PD Behavior during PSE Transient D1.2 comment # 232, v3

Fred Schindler, Seen [Simply](#)

Figure 33-18—PD static operating mask

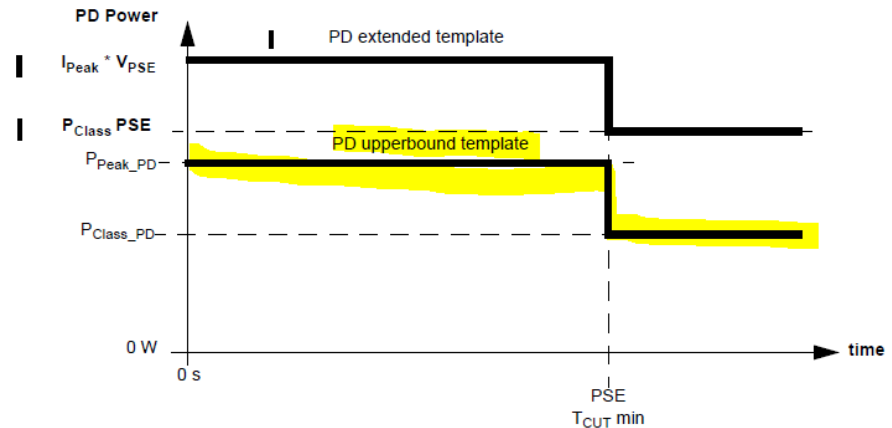
- The existing PD static operating mask is for the total PD power.
- DS PD are should have the same class value on each Mode. DS PDs were tested the same as SS PDs.

Replace Figure 33-18 with the following figure:

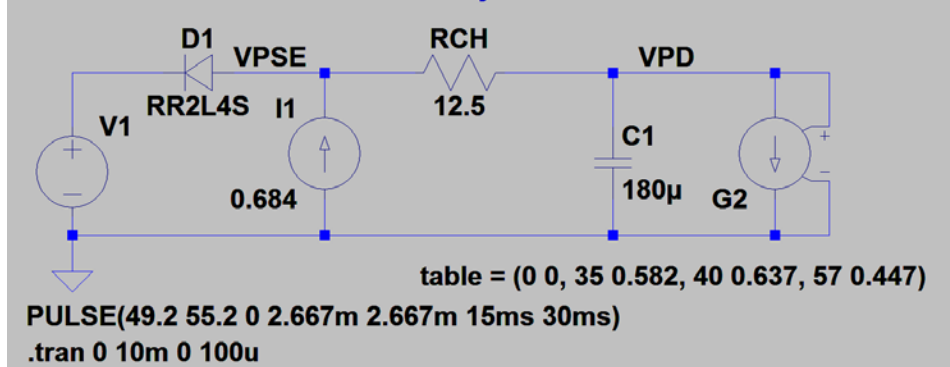
“2. A drop out specification needs to be added to this section that requires PDs to ride out PSE transients. This is in place of increasing Cport.

Strike Editor's Note,
